**PG&E Letter DCL-03-077**

**Docket No. 50-275, OL-DPR-80**  
**Docket No. 50-323, OL-DPR-82**  
**Diablo Canyon Units 1 and 2**  
**Response to NRC Questions Regarding License Amendment Request 02-03,**  
**"Spent Fuel Cask Handling"**

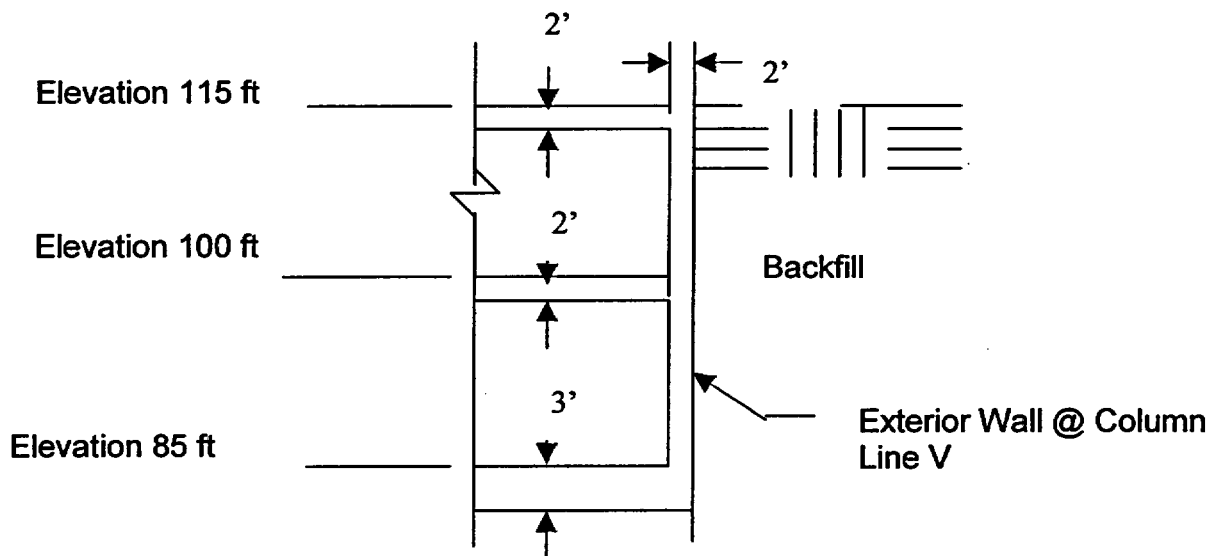
You stated in page 16 of the Reference that "...The wall has been judged adequate with respect to lateral pressure related to the surcharge loads..." Provide the following:

- a) General description of the wall system (e.g., physical dimension, material type and current lateral pressure).
- b) The increased lateral pressure along the wall due to the surcharge.
- c) Technical justification on how the wall is adequate with respect to the lateral pressure related to the surcharge loads.

- a) The 2 ft thick wall is located on the east side of the auxiliary building and extends from the south end at Unit 2 to the north end at Unit 1. The wall extends vertically from elevation 82 ft to elevation 140 ft. The back filled portion of the wall extends from the bottom to elevation 115 ft. There are 2 ft thick slabs at elevation 115 ft and elevation 100 ft, and a 3 ft thick slab at elevation 85 ft, which provide horizontal support to the wall from the inside of the building.

The current maximum design lateral earth pressure is 0.75 ksf at elevation 85 ft. This equates to a maximum moment (8.41 ft-k) vs allowable moment (82 ft-k) ratio of 0.103 for the wall.

- b) The addition of the surcharge of the loaded cask transporter increases the lateral earth pressure by 0.355 ksf max.
- c) Calculations have been performed to qualify the wall for the increased pressure. The transporter's track pressure of 3.57 ksf was conservatively assumed to occur as a uniform surcharge over the entire ground behind the wall in the calculations. The maximum clear span for calculating moments is 13 ft. A fixed-fixed wall end condition was used for the critical span between elevation 85 ft and elevation 97 ft. The maximum wall moment to allowable moment ratio increased from 0.103 to 0.133, which is still within allowable limits.

Figure 2-1 – Conceptual Vault Remediation

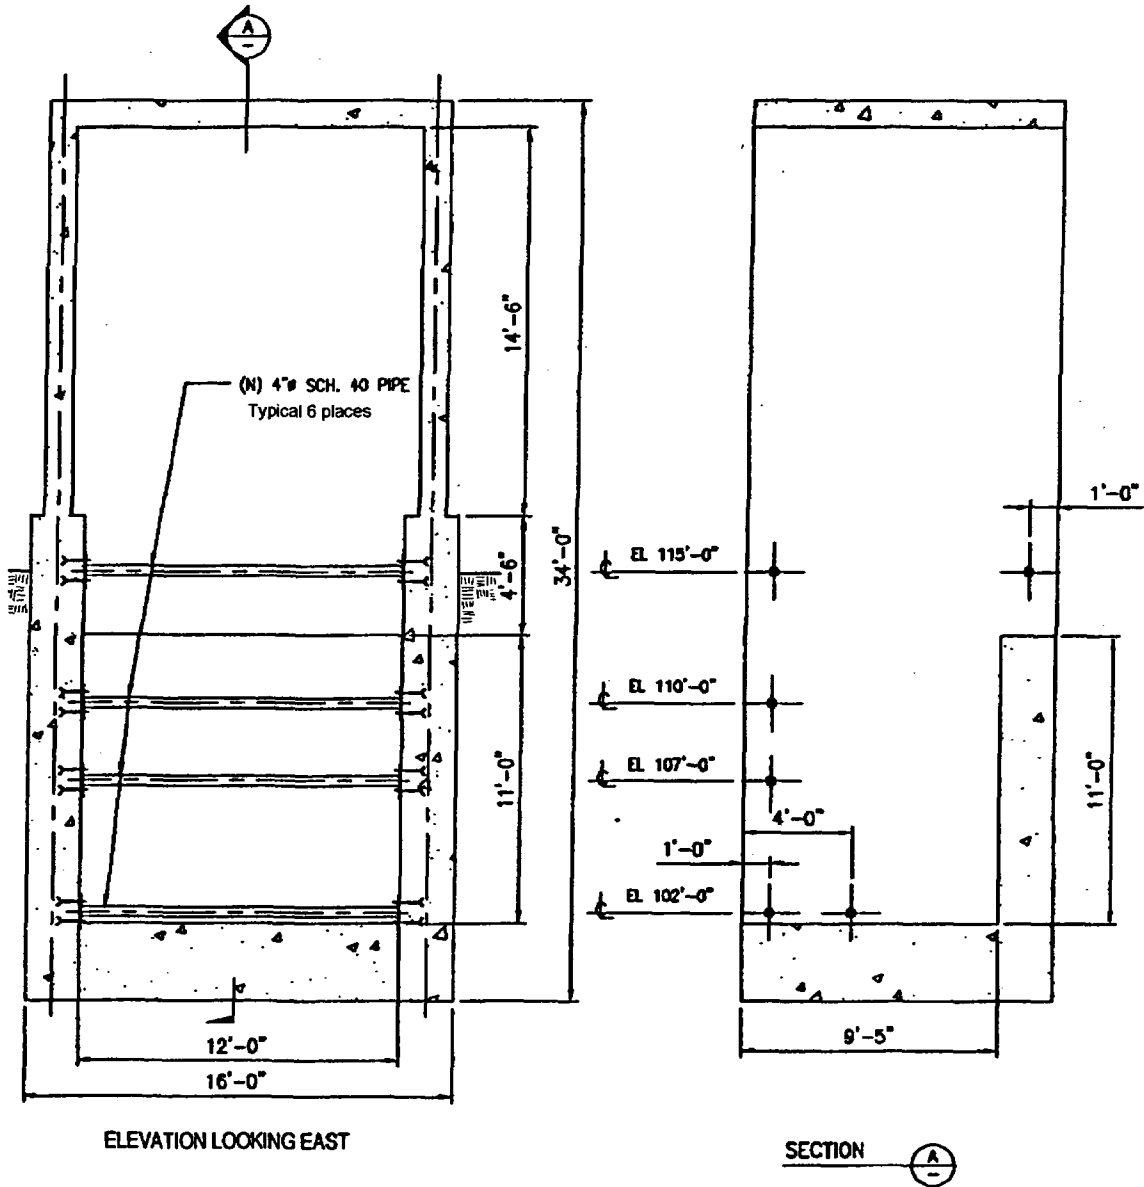
*You stated in page 16 of the Reference that "...Vital water tank piping vault ... Initial assessment indicates a need for more detailed evaluation and/or analyses ..." Provide the following:*

- a) *What evaluation and/or analyses do you plan to perform?*
- b) *Submit the results of the evaluation and/or analyses to the NRC for review.*

- a) A detailed structural evaluation was performed to verify that the underground non-safety-related walls of the piping vaults for the Design Class I outdoor water storage tanks and the non-safety-related primary water storage tanks can accommodate normal and abnormal loading conditions per the acceptance criteria in FSAR Update Section 3.8.2.

- b) The results show that the vault walls are overstressed for the normal condition and for the abnormal condition that combines seismic and cask transporter surcharge loading. Capacity to demand ratios for the various loading conditions are tabulated in Table 2-1. The vault walls will be remediated prior to cask transport operations so that the walls meet the appropriate acceptance criteria. A conceptual remediation is shown in Figure 2-1. The remediation deploys shoring struts at selected elevations in the vault to support the vault walls. The wall flexure load is reduced by the distributed action of the axial forces in the struts to the opposing wall surface.

Figure 9-1

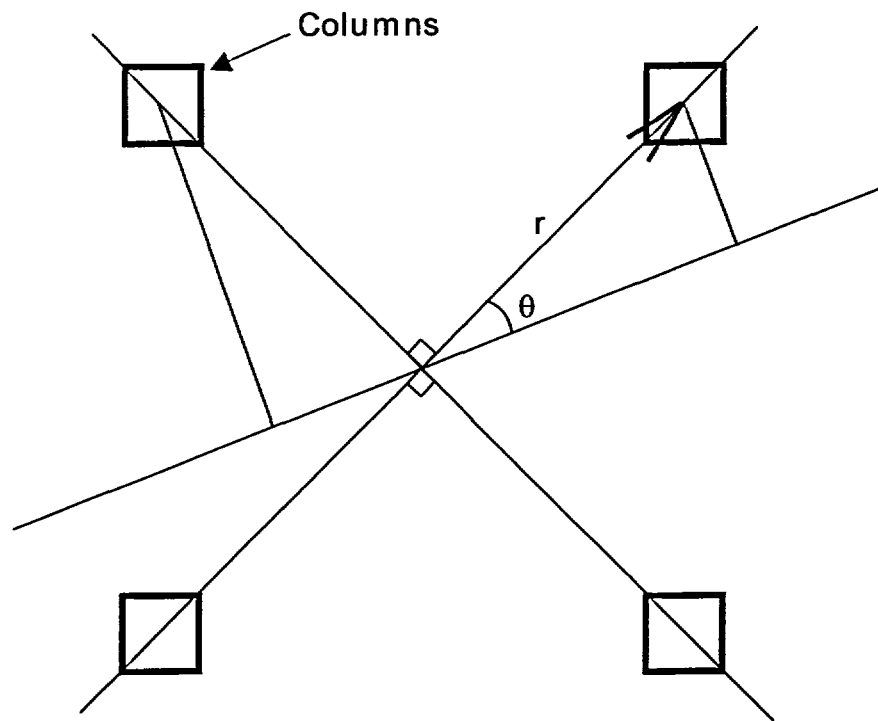
- b) Explanation and justification for consistency between the stiffness calculation of the structure in 2-D nonlinear dynamic analyses from the stiffness developed from the 3-D linear static analyses.*

The dynamic properties of the SFP Frame are dependant on the area moment of inertia, the distance between supports and support conditions, the modulus of elasticity and the mass density of the structure. If all these properties do not vary in one of the three spatial dimensions then the SFP Frame can be modeled by a two dimensional model. The modulus of elasticity and the mass density of the structure are uniform throughout.

The four columns of the structure are the significant contributors to the area moment of inertia (see Figure 9-1). As shown in Figure 9-1, the area moment of inertia of a regular frame structure such as the SFP Frame is not a function of the angle  $\theta$ . There is an opening on the east side of the frame that allows fuel to be loaded into the cask. The effect of this opening on the overall stiffness of the frame is minimal. Due to the SFP Frame's column connectivity, only small variations in the stiffness in the NS and EW directions at various elevations were found (PG&E Calculation 52.15.136).

Figure 9-3 – Cask Restraint at Elevation 111 ft 0 inches

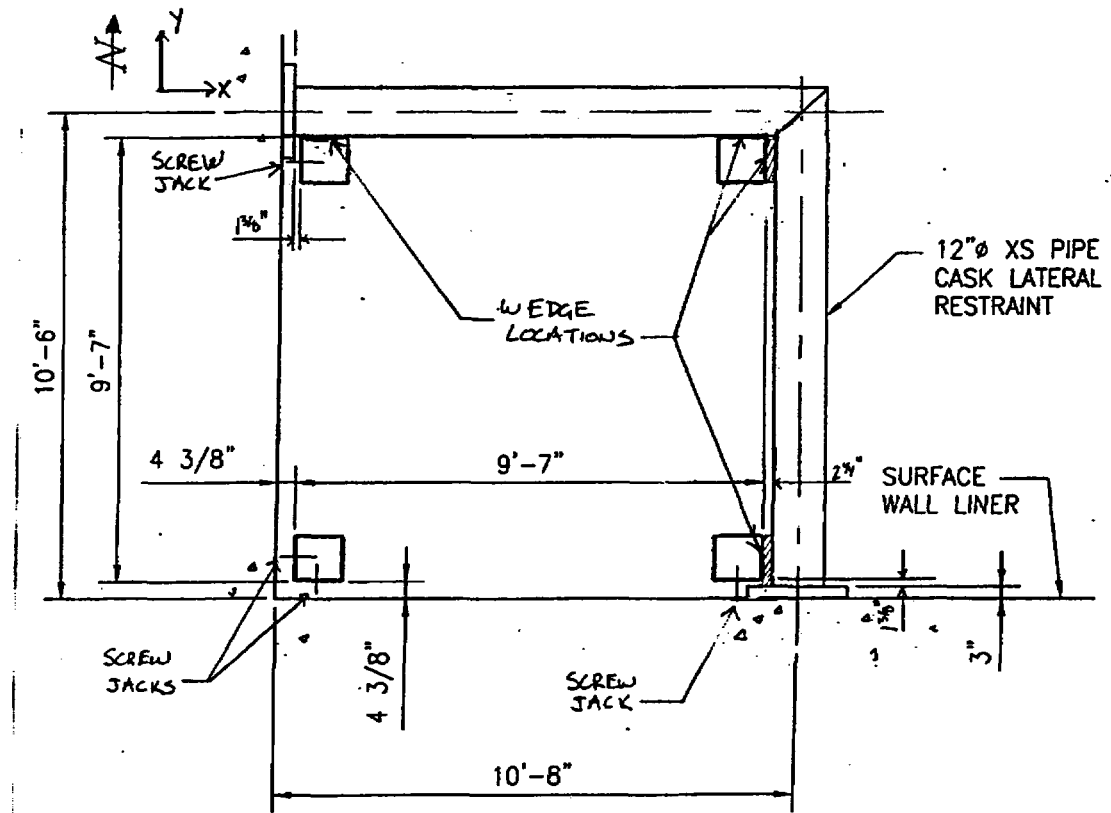
- d) The results of the 3-D static analyses for structural member sizing and support reactions with the structural acceptance criteria used.*
- e) Description of the restraint and the results of the analyses for the restraints on the SFP frame at Elevation 111 ft. and 140 ft.*

e) SFP Elevation 111 ft restraint:

The elevation 111 ft restraint frames around the cask recess area in the SFP. The restraining pipes, horizontal and vertical, are 12 inch $\phi$  Schedule XS Type 304 stainless steel. The support was analyzed and found to meet the acceptance criteria as described in Response 9d. A plan view of the support at elevation 111 ft is shown in Figure 9-3. The SFP frame column placement is shown also. The maximum reactions are shown in Table 9-2. It should be noted that screw jacks are located at the NW, SW, and SE frame columns at elevations 111 ft 0 inches and 94 ft 6 inches.

**Figure 12-1 – Plan View of SFP Walls (Unit 1 shown)**

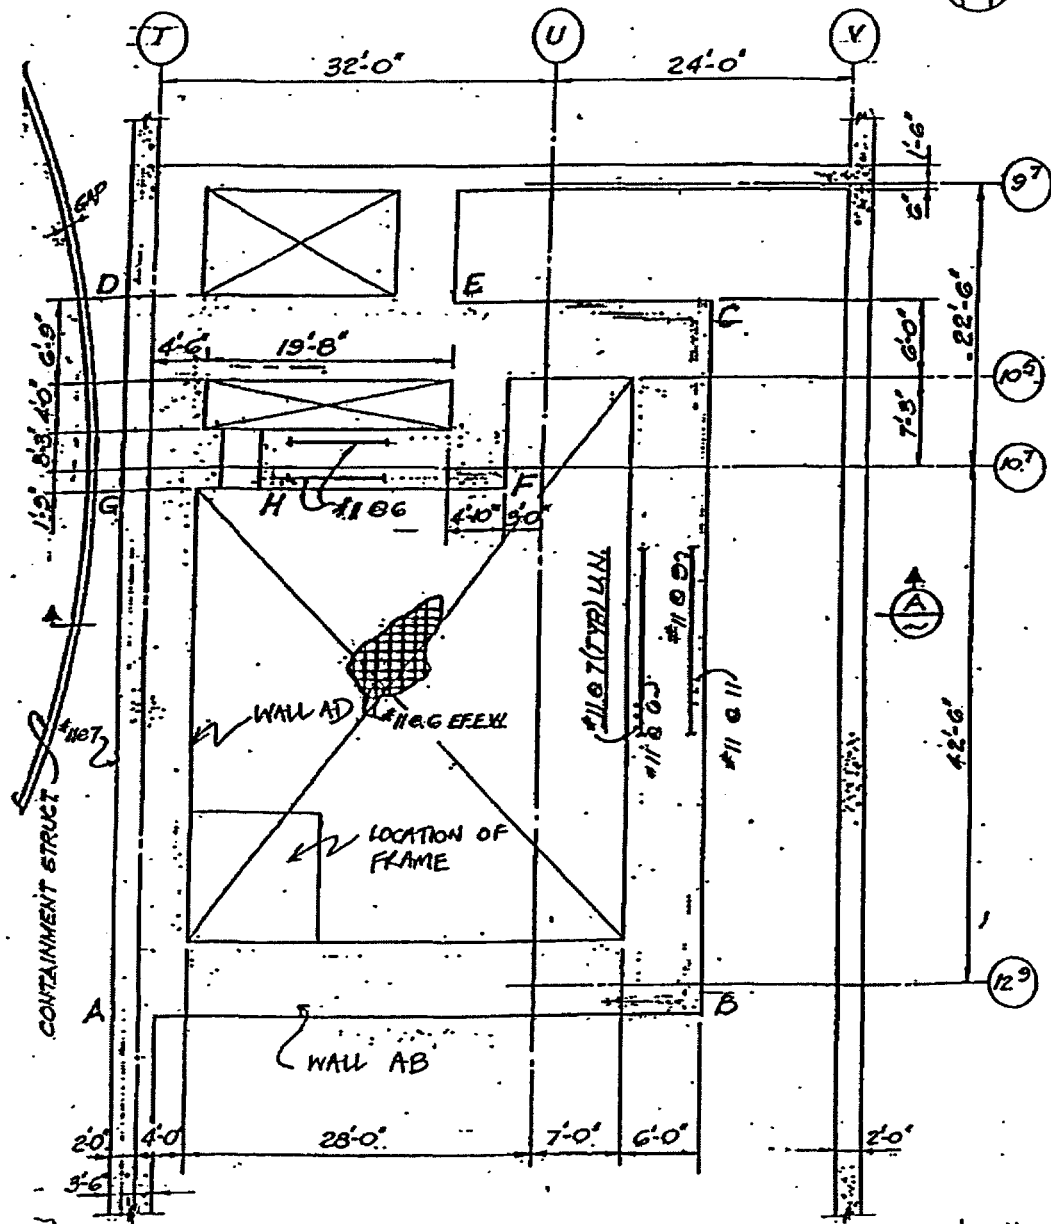
- a) Provide the physical dimensions of the SFP including the thickness of the reinforced concrete (RC) slab and walls and liner plate.*
- b) Provide a copy of the mesh used in the analysis.*
- c) Describe the boundary conditions used.*
- d) Describe the applied loading conditions including their magnitudes.*
- e) Explain how the SSE loading was applied to the SFP. If you used equivalent static analysis, provide justification for this approximation. What were the magnitudes of the equivalent static accelerations applied at mass points you used in the analysis?*

- a) The SFP is a Design Class I, safety-related reinforced concrete structure. The pool walls and base-mat provide containment for the borated water within the SFP. A plan view of the pool at elevation 140 ft is shown in Figure 12-1. The walls of interest are labeled Wall AB & AD (on grid lines 12<sup>g</sup> and T, respectively).
